Technical Service Bulletin

01 - MIL on, Whistling noise, leaking air Bank 2 - DTC P2ADF00, Engine Crankcase breather

01 23 72 2071318/1 August 23, 2023.

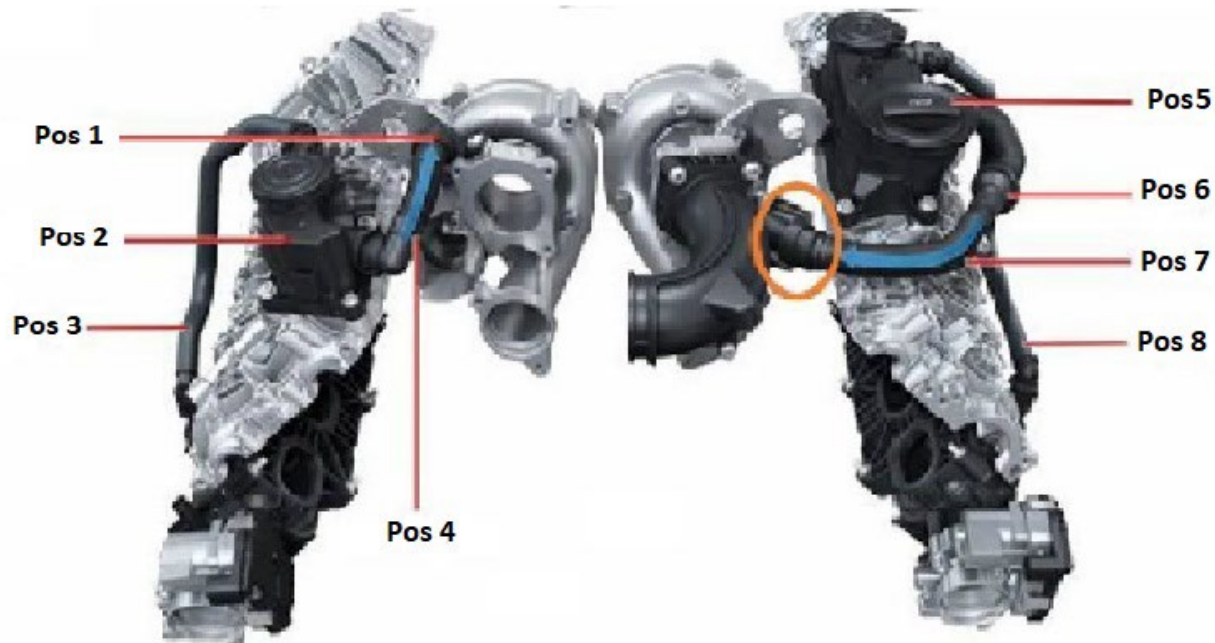
In this case, replace the full load breather line for cylinder bank 2.

1. Do not replace the oil separator for bank 1 or bank 2 or the part load breather lines.
 - a. Please refer to image of the crankcase from the Self Study Program 920493 as a guide.

- Item 1: Non-return valve
- Item 2: Oil separator for bank 1
- Item 3 Part load breather line for bank 1
- Item 4: Full load breather line for bank 1
- Item 5: Oil separator for bank 2
- Item 6: Non-return valve
- **Item 7: Full load breather line for bank 2**
- Item 8: Part load breather line
